UNITED STATES PATENT AND TRADEMARK OFFICE

10/590,284

| Office Action Summary | Application No. 10/590,284 | Applicant(s) ABUMUSTAFA, ANWAR | |

DETAILED ACTION

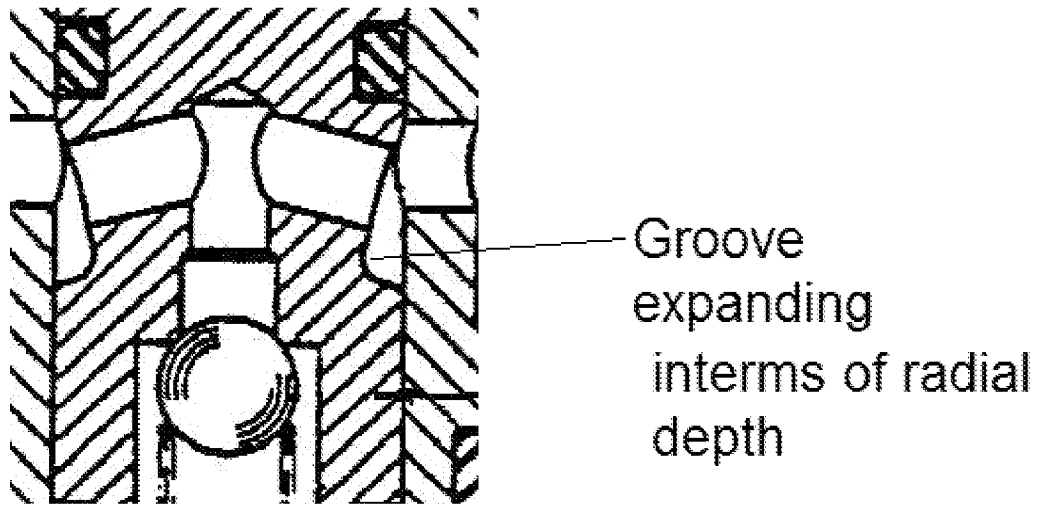
- Axial inflow orifice (18) extending cylindrically to a beginning of radial outflow orifices (26), in figure 1. Abumustafa's admitted prior art in view of Yarnall et al. however fails to disclose the following limitation which is taught by Bartussek et al.
- Circumferential outflow groove (marked below for clarity). expanding in terms of a radial depth on an outer circumference of the piston towards the control edge, in figure 5 .

- The outflow groove expands in a conical form on a piston side and, as the result of a radially, inwardly directed arc, subsequently reaches a greatest depth in a region of the control edge (clearly shown in the marked drawing above).

- Diameters of the radial outflow orifices extend from the axial, cylindrical inflow orifice into the radially, inwardly directed arc in the control edge region (see figure above).
